RE: Exhibition of Modification 4 to SSD-11429726 at 161-173 Princes Highway, Arncliffe

Thank you for the opportunity to provide comment on the fourth modification for the Mixed Use Redevelopment at 161-173 Princes Highway, Arncliffe (the site). Council is currently negotiating with the proponent to acquire the community facility space. The proposed modification comprises:

Figure 1: Through Site Link

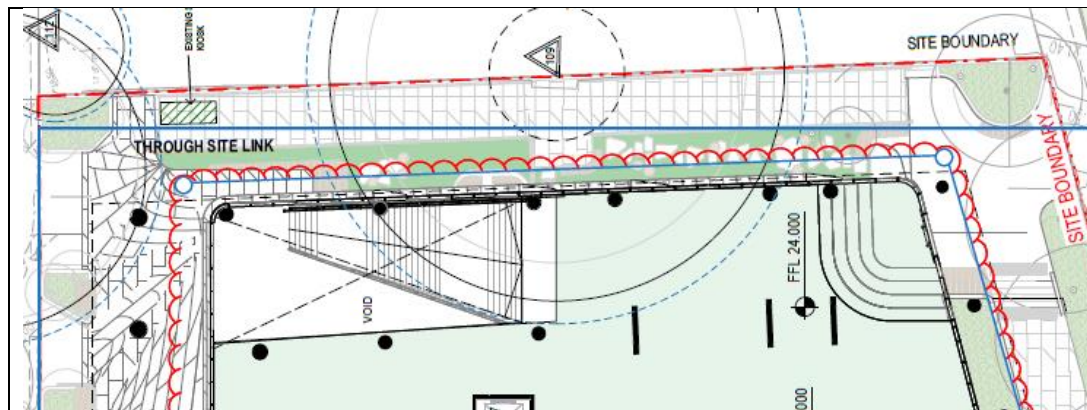
The community facility has been located with direct access to the public domain along the site's northern boundary. Developments have been made to the northern cross site link to connect to the community facility and in principle these are positive developments.

However, detail resolution of community facility layout should seek to maximise casual surveillance / activation of the pedestrian link.

Figure 2: Community Centre Bathrooms

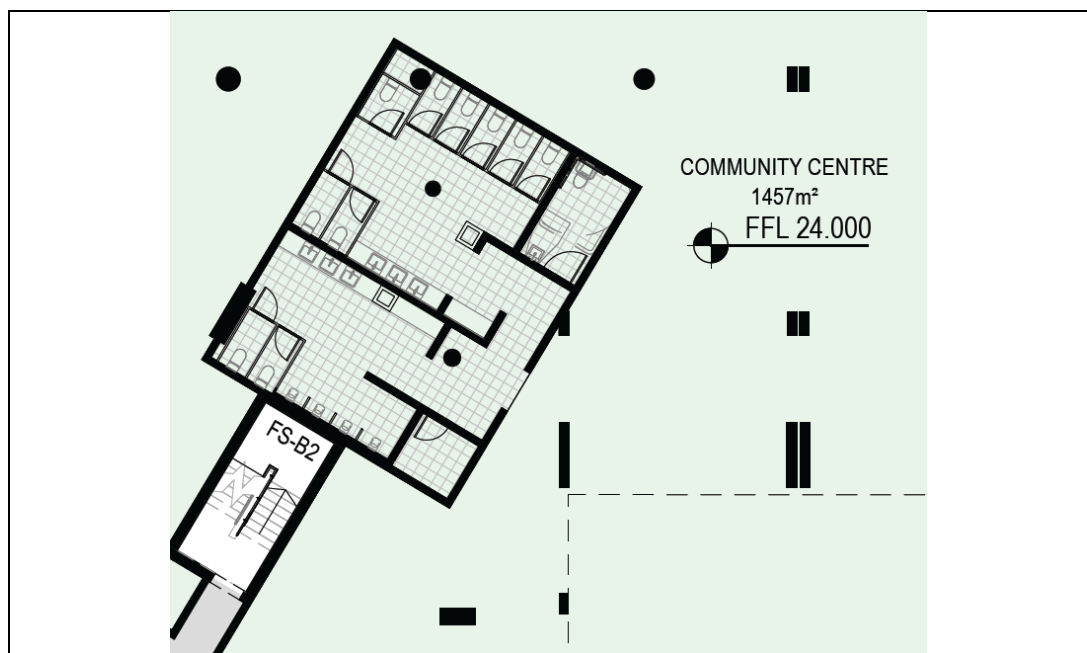
Some elements of the facilities are shown in detail on the proposed architectural plans. Council is still negotiating with the proponent over details relating to the fit out and therefore it is not appropriate for the bathroom layout to be shown at this time. This level of detail will be resolved as part of a future approval.

The plans should be amended to remove all detail showing the layout and features of the community facility bathrooms.

Figure 3: Meeting Place

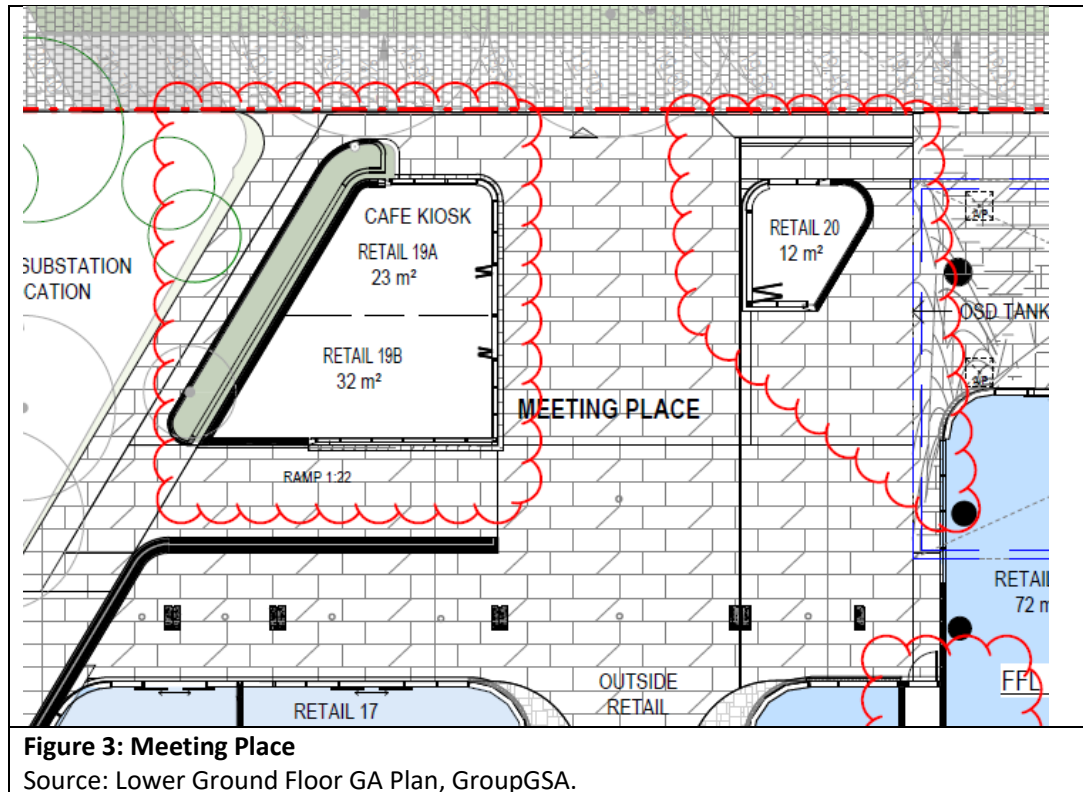
An increased area of retail space has been developed within the meeting space, effectively reducing the extent of public domain. The space now appears to be a generously proportioned external circulation area, rather than a functional public square.

Any built form interventions within this space should be minimal in footprint and have a use consistent with the nature of the meeting space. A small kiosk / café could provide a positive contribution to the space, whereas a general-purpose retail tenancy would detract from the quality of the space.

Figure 5: Deep Soil Zone – not reflecting new proposed substation location
Source: Deep Soil Diagram, GroupGSA.

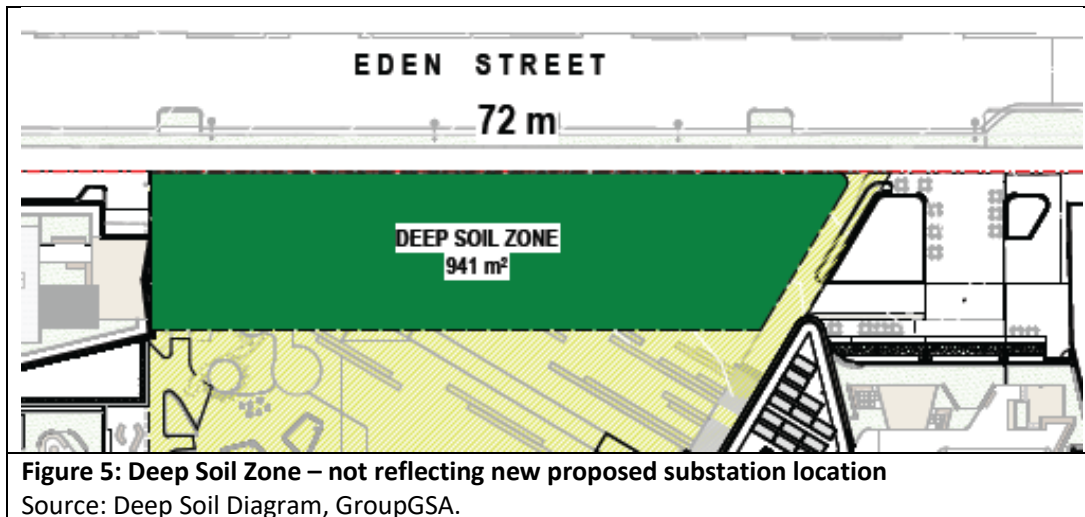
The new substation location does not appear to be reflected in the Deep Soil Diagram (Drawing DA 4300) or in calculations of the amount of deep soil area provided in the modification report. An excerpt is provided below:

In addition to the details for siting of the substation, the proposal should provide an updated Deep Soil Diagram and deep soil area calculation to demonstrate whether compliance is achieved.
